# METROPOLITAN GOVERNMENT OF NASHVILLE AND DAVIDSON COUNTY

## STAFF RECOMMENDATION 810 Petway Avenue August 20, 2014

**Application:** New construction-infill  
**District:** Greenwood Neighborhood Conservation Zoning Overlay  
**Council District:** 06  
**Map and Parcel Number:** 08204031800  
**Applicant:** Steve Morgan, Handyman Service  
**Project Lead:** Melissa Baldock, [Melissa.baldock@nashville.gov](mailto:Melissa.baldock@nashville.gov)

**Description of Project:** Application is to construct new single-family infill.

# Site Plan

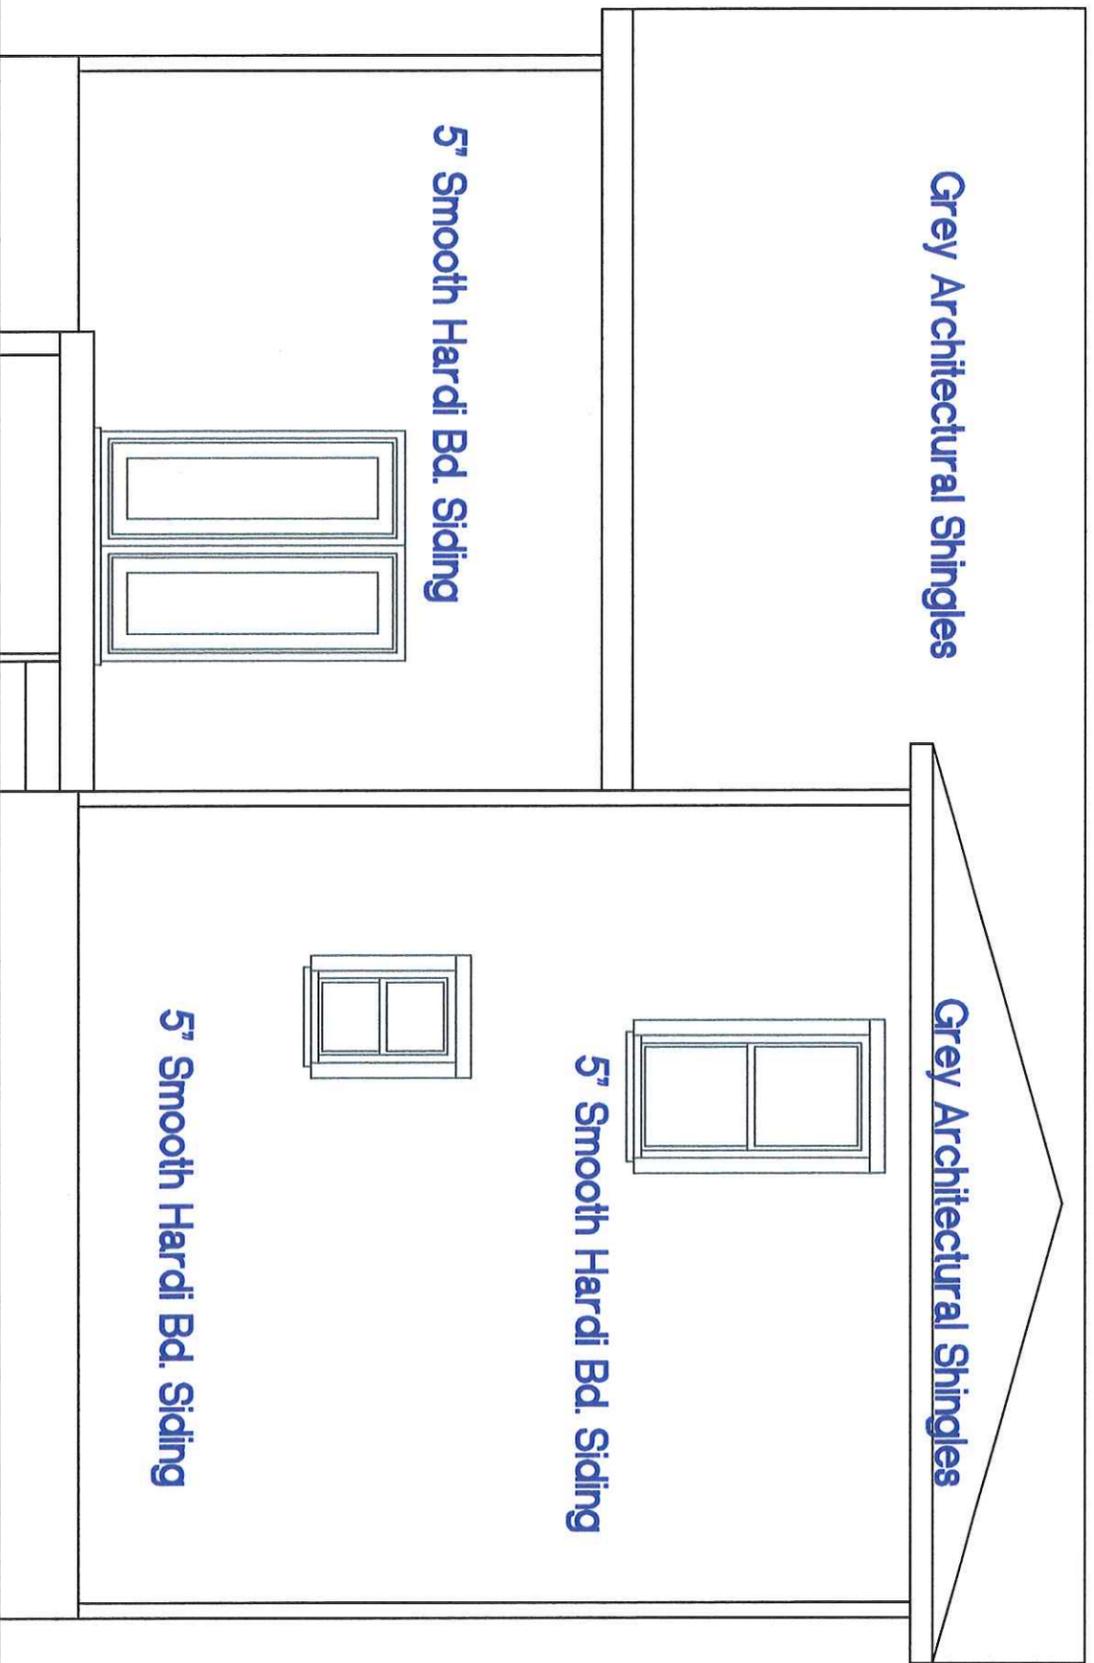
**Setback & Rhythm of Spacing:** The infill will meet all base zoning requirements. It will be at least five feet (5') from the left/east side property line, and over ten feet (10') from the right/west side property line. It is shifted on the lot to allow for the use of an existing driveway. It will be over forty feet (40') from the rear property line. The site plan shows that the infill will be approximately forty-one feet, six inches (41'6") from the front

property line, which seems to approximately match the front setback of the adjoining properties. Staff asks to verify in the field that the front setback of the new infill's front wall matches the front setback of the adjacent properties. With this condition, staff finds that the infill's setback and rhythm of spacing meet Section II.B.1.c. of the *Greenwood Neighborhood Conservation Zoning Overlay: Handbook and Design Guidelines*.

Outbuildings: The site plan indicates that the existing garage, which is twenty-four feet by thirty feet (24' X 30') will remain.

**Front Elevation**

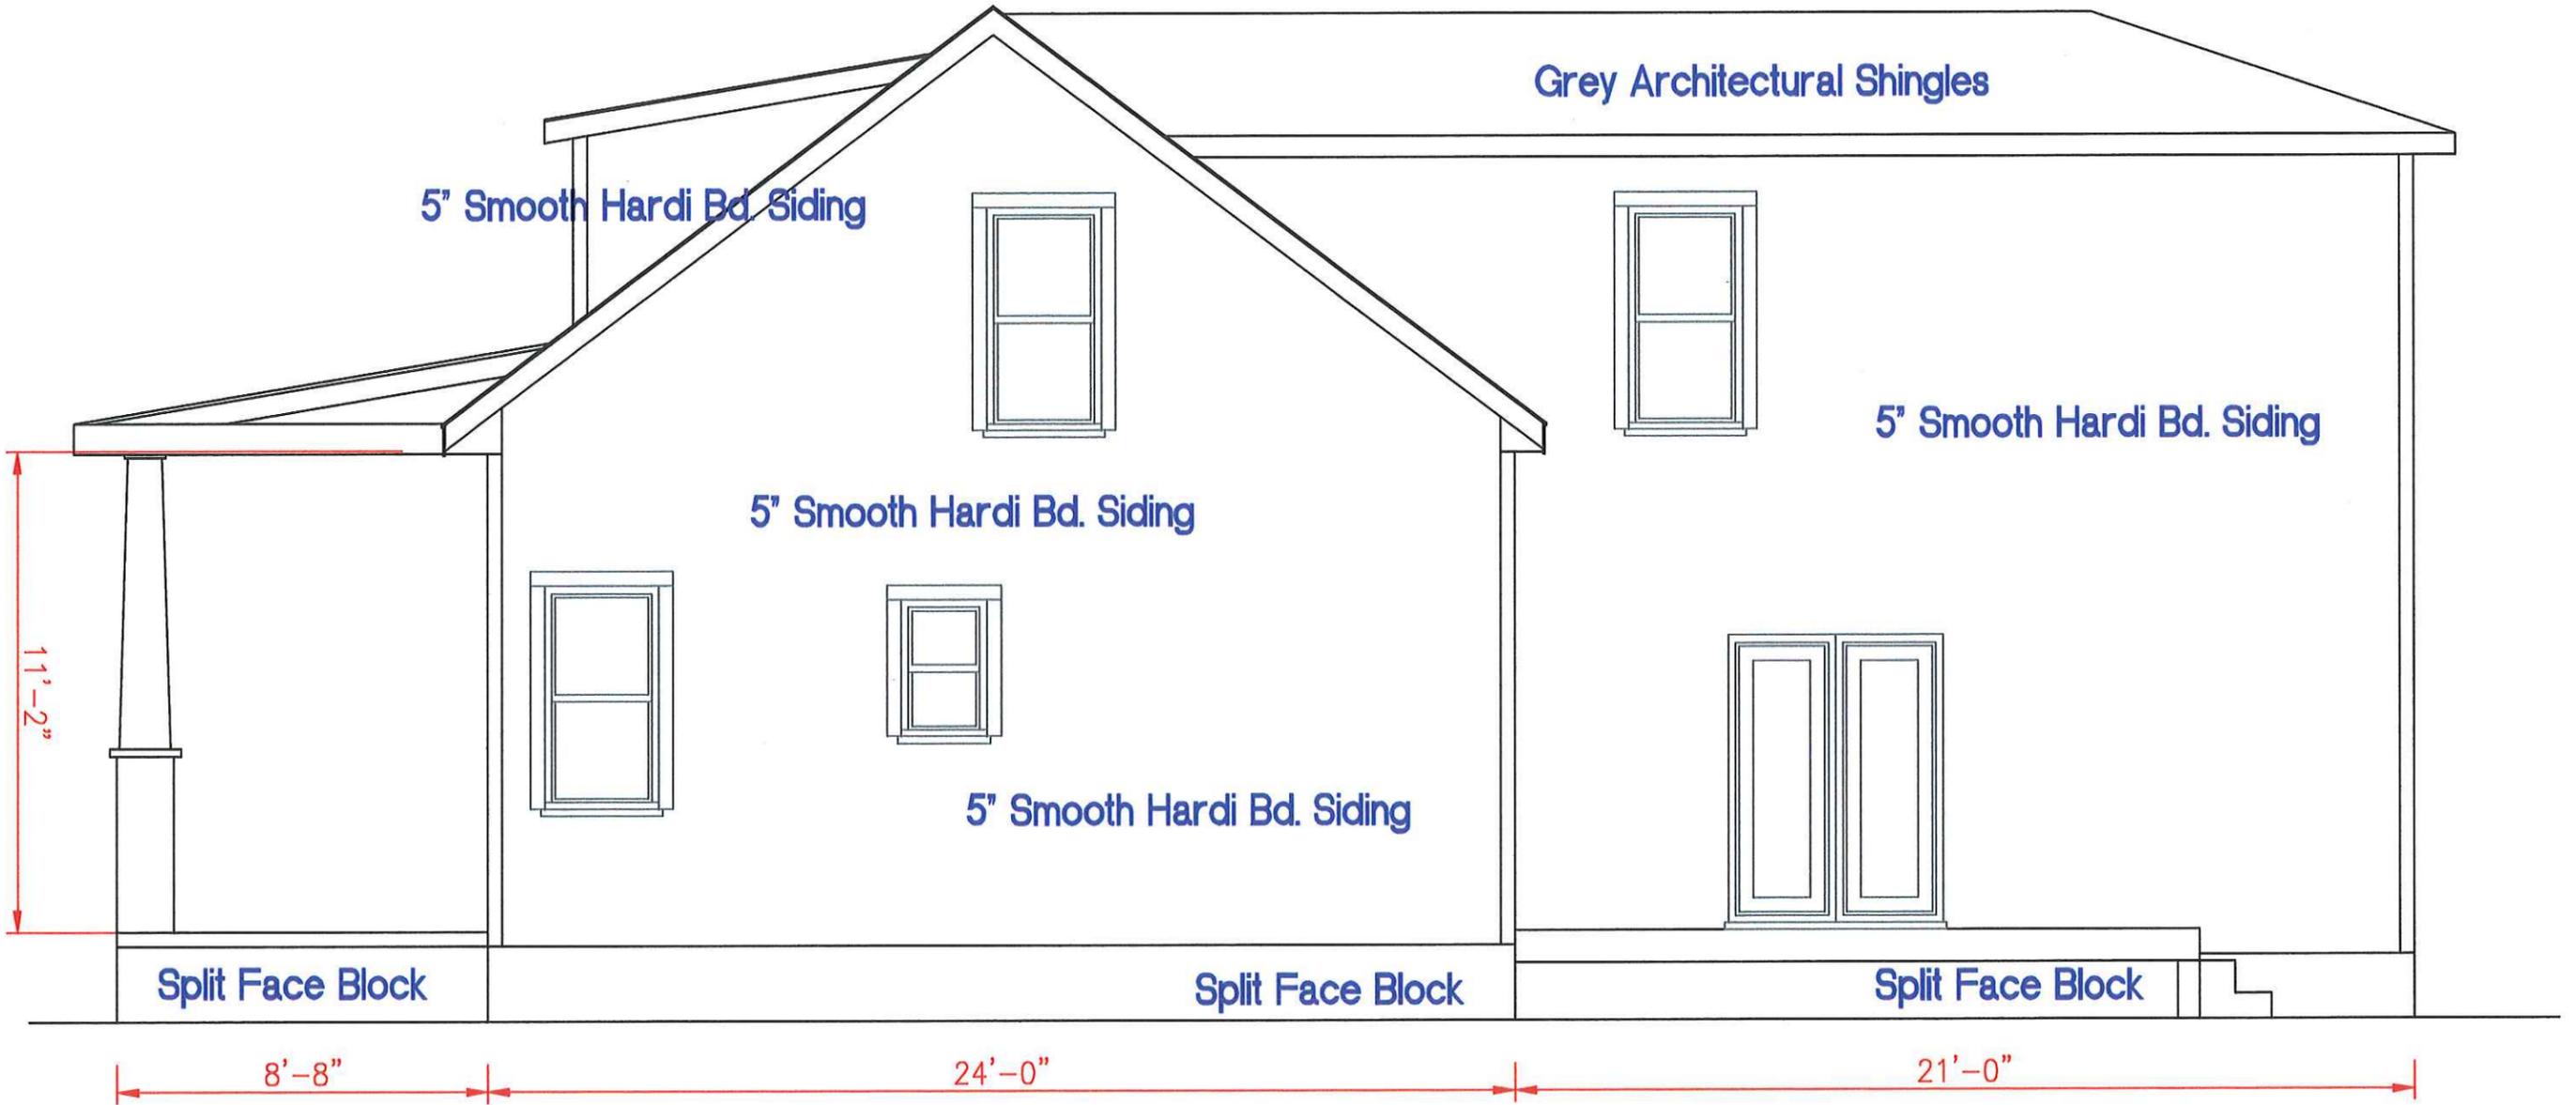
Roof form: The infill's primary roof form is a side gable with a slope of 9/12. The porch roof is a low shed roof, with a slope of 3/12, and the rear extension has a hipped roof, with a slope of approximately 4/12. The front dormer is situated off of the house's ridge, and is setback two feet (2') from the wall below. It has a shed roof with a slope of approximately 2/12. Staff finds that the infill's roof forms meet Section II.B.1.e. of the *Greenwood Neighborhood Conservation Zoning Overlay: Handbook and Design Guidelines*.

Orientation: The infill is oriented to face Petway Avenue. It has a central, partial-width front porch that is eight feet, eight inches (8'8") deep. Its doorway is centrally located on the façade. Vehicular access to the site will come from an existing driveway. No walkway was included on the plans, and staff asks that a central walkway be installed on the site, leading from the front of the property to the front porch, with staff approval of location and material. With this condition, Staff finds that the infill's orientation meets Section II.B.1.f. of the *Greenwood Neighborhood Conservation Zoning Overlay: Handbook and Design Guidelines*.

Proportion and Rhythm of Openings: The windows on the infill are all generally twice as tall as they are wide, thereby meeting the historic proportions of openings. There are no large expanses of wall space without a window or door opening. Staff finds the infill's proportion and rhythm of openings to meet Section II.B.1.g. of the *Greenwood Neighborhood Conservation Zoning Overlay: Handbook and Design Guidelines*.
